Access Compliance Report

Public Rights-of-Way

(Pedestrian Signals)

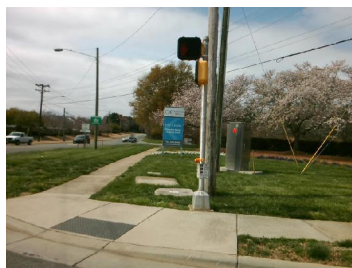
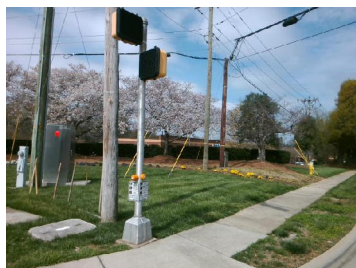
Intersection ID: N/A	Main Street:	Cross Street: N/A	Location: N/A
ADA ID: DD72F53FAB8B	Signal Type: Two Push Buttons-Non APS	Overall Compliance: No	Severity Score: BTN 1:N/A BTN 2: N/A No BTN: N/A
Codes/Mitigation Info/Possible Solution		Field Measurements/Component Compliance

PROW/ADA: R404.2, R404.3, R404.7.2

Possible Solutions: Remove and Replace Clear Space.
